## Comment Set F Pacific Gas & Electric Company

Re: Draft Mitigated Negative Declaration and Supporting Initial Study for the Embarcadero-Potrero 230 kV Transmission Project (A.12-12-004)

### APPENDIX A: IDENTIFICATION OF TYPOGRAPHICAL ERRORS AND INTERNAL INCONSISTENCIES

Appendix E – Revised Potrero 230 kV Switchyard West Elevation Drawing

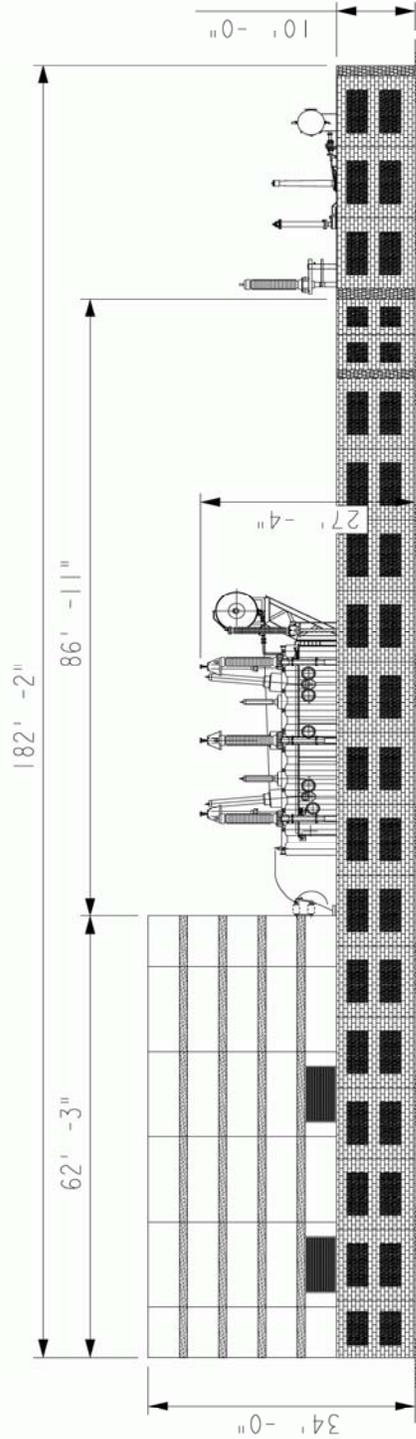
Additionally, the Commission should modify Figures 4-14 and 4-15 in the MND to be consistent with the updated drawings provided in Appendices C-G to this letter. Appendix C is a revised site plan for the switchyard. Appendices D-F are revised elevation drawings showing the current design profile looking toward the east, west, and north, respectively. Appendix G is an aerial view of the area with outlines showing the revised shape of the land rights PG&E intends to acquire from NRG (formerly GenOn), including the land needed for the switchyard and Alternative 1 for the construction staging site.

- F-5 Figure 4-14 (Potrero Gas Insulated Switchgear Building Conceptual) and Figure 4-15 (230 kV Electrical Equipment) have been replaced in the Final IS/MND by revised figures submitted as Appendices C-G. The following new figures are included in the Final IS/MND:

- Figure 4-15a (Revised Potrero 230 kV Switchyard East Elevation),
  - Figure 4-15b (Revised Potrero 230 kV Switchyard West Elevation), and
  - Figure 4-15c (Revised Potrero 230 kV Switchyard North Elevation).

Appendix G – Revised Parcel Map for Private Land Rights Acquisition near Potrero Switchyard

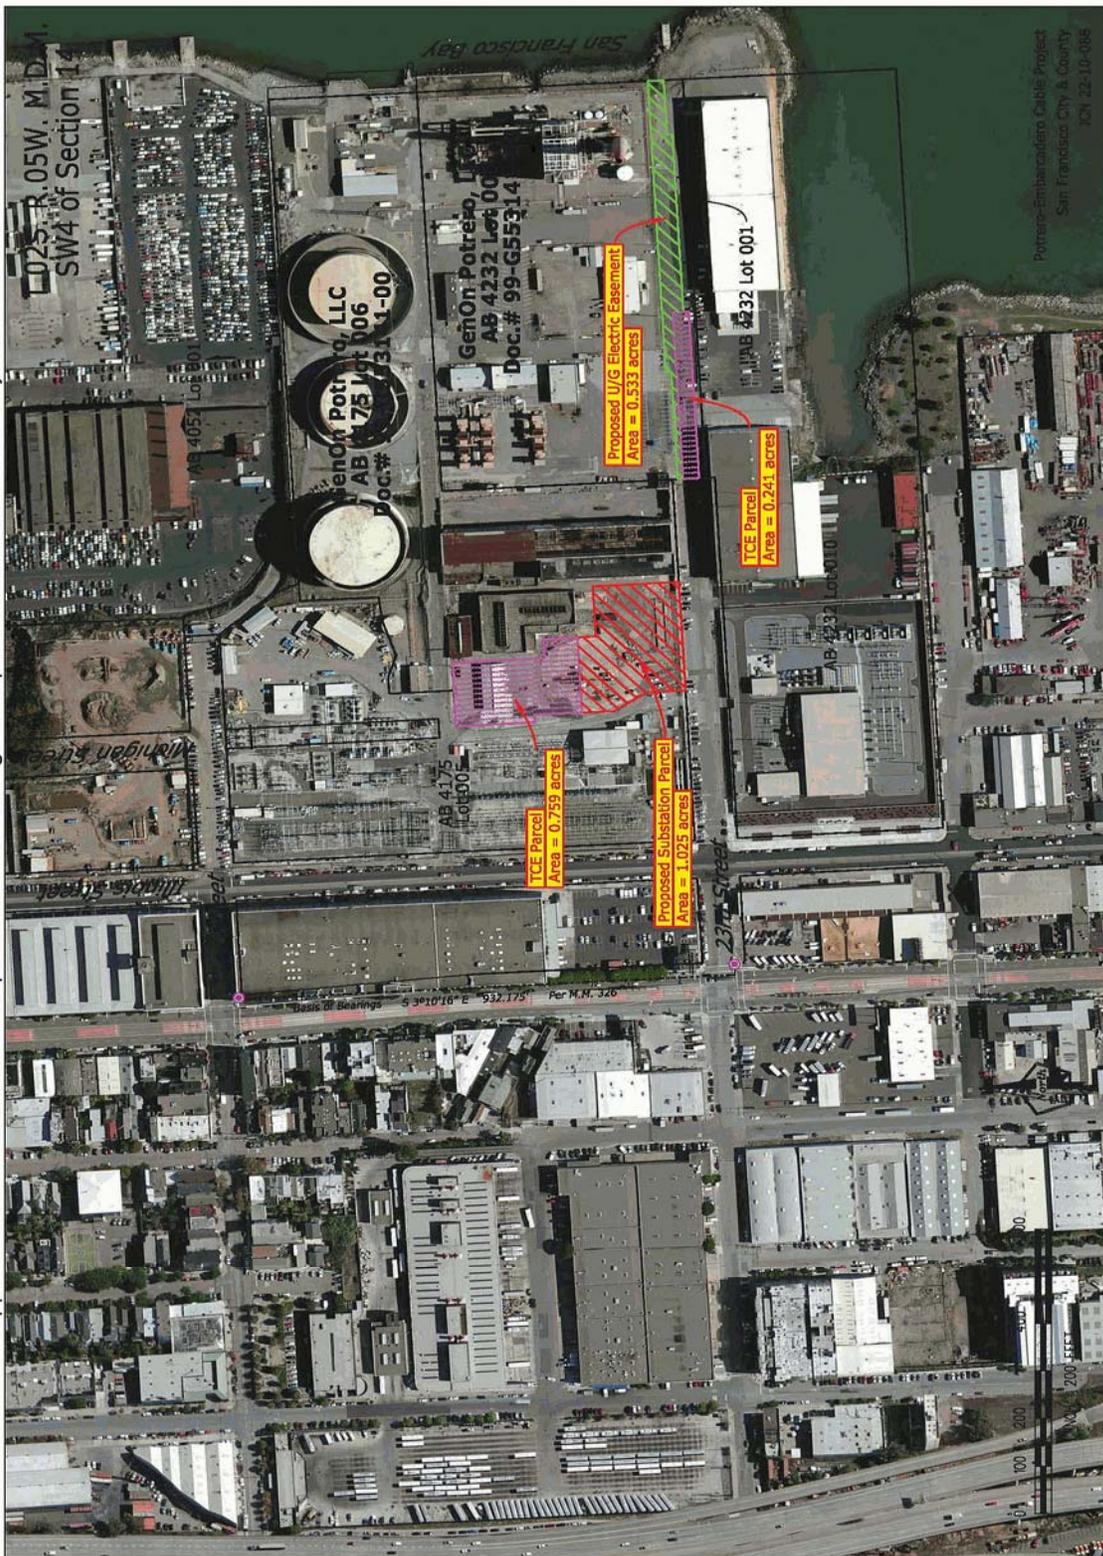
Finally, the Commission may wish to modify figures that generally show the shape of the parcel that PG&E intends to acquire in fee simple and the resulting changes in the shape of the proposed construction staging site (Alternative 1) to ensure consistency with Appendix G to this letter. This may require very minor changes to the polygons in Figures 4-2, 4-4, 4-5, 4-9, and 5-10.2.

- Figure 4-14a (Revised Site Plan for Proposed Potrero 230 kV Switchyard),
  - Figure 4-14b (Revised Parcel Map for Private Land Rights Acquisition near Potrero Switchyard),

- Edits that reflect the independent review by the CPUC Energy Division appear throughout the environmental analysis (Chapter 5, Initial Study).
- F-6 See Response to Comment F-5 regarding a new Figure 4-14b showing the revised parcel map for private land rights acquisition near Potrero Switchyard. In addition, minor changes to the parcel polygons shown in Figure 4-2 (Project Location), Figure 4-4 (Potrero Switchyard Area), Figure 4-5 (Potential Staging Locations), Figure 4-9 (Potrero HDD Transition Area), and Figure 5.10-2 (Potrero Area Existing Land Use) have been made in this Final IS/MND. See also Response to Comment F-10 regarding additional revisions to Figures 4-2 and 4-4 and the text in Sections 4.11.3 (Staging Areas, Onshore Staging) and 4.11.4 (Easements and Right-of-Way).

Appendix H: Submarine Cable Diagram Assuming Double Steel Armoring Design

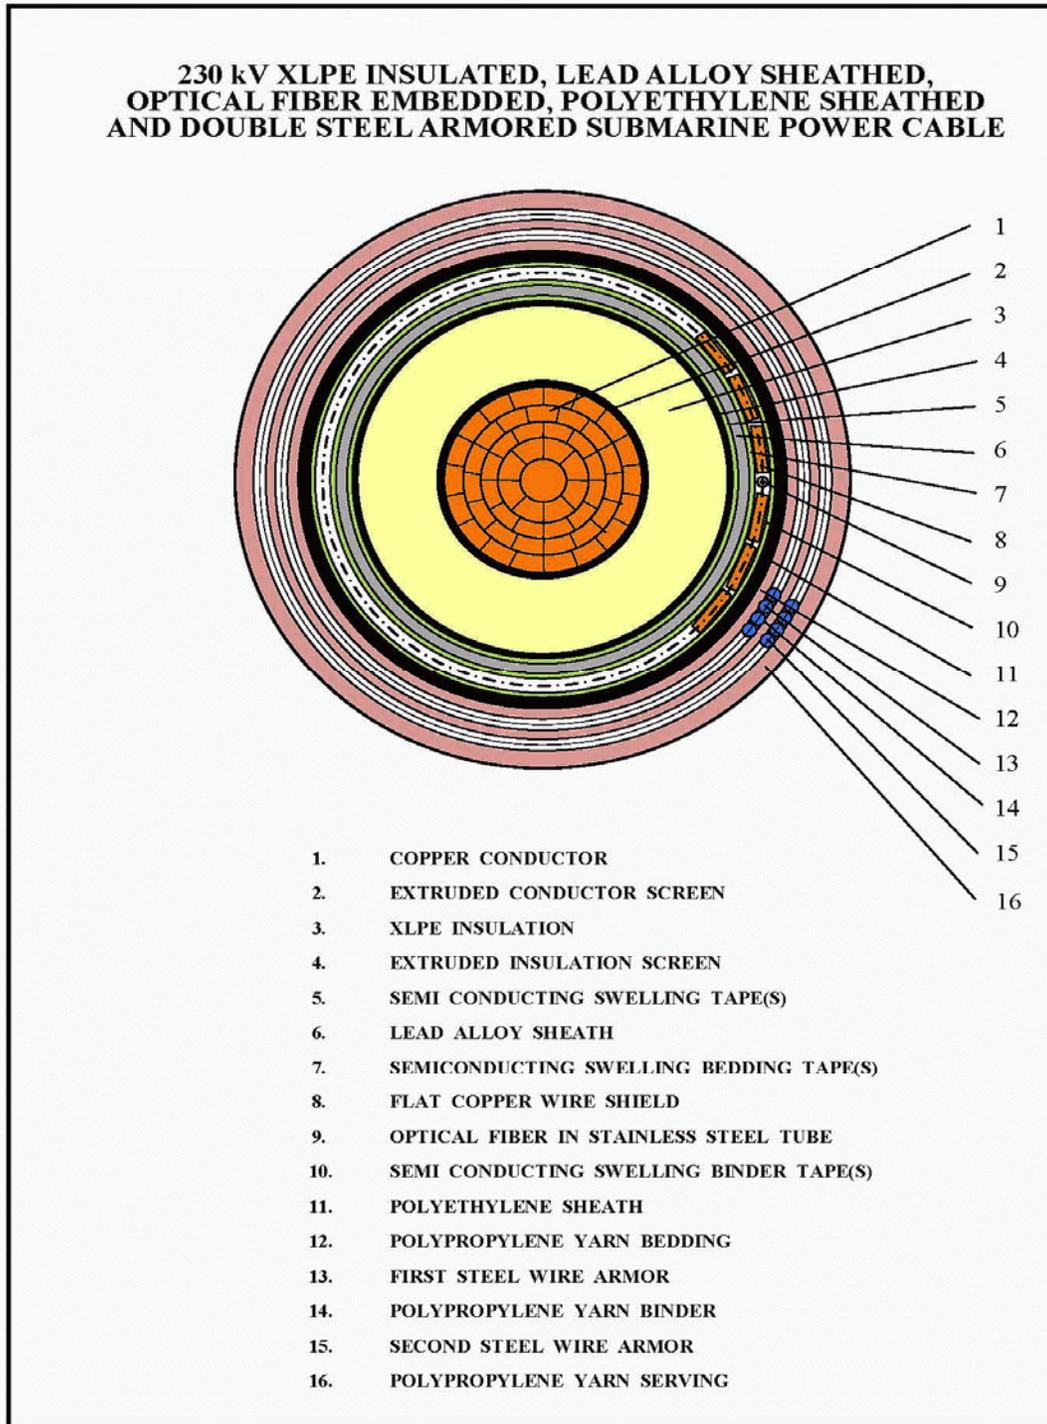
Based on the most recent conceptual design work, PG&E requests that the MND be modified to provide for additional flexibility to accommodate potential design elements that would increase the value of the line without introducing new or different environmental impacts. Specifically, PG&E is now planning to specify two layers of copper or steel armor on the submarine portion of the cable in order to increase its tensile strength. Because Figure 4-13 only shows one layer of copper wire armor, PG&E requests that it be replaced with Appendix H to this letter (double steel armoring) and Appendix I to this letter (double copper armoring), as alternative options.

- F-7 Figure 4-13 (Cross Section of the Proposed 230 kV XLPE Submarine Cable) has been replaced in the Final IS/MND with the following two revised figures submitted as Appendices H and I:

- Figure 4-13a (Cross Section of the Proposed 230 kV XLPE Submarine Cable with Double Steel Armoring Design)
  - Figure 4-13b (Cross Section of the Proposed 230 kV XLPE Submarine Cable with Double Copper Armoring Design)
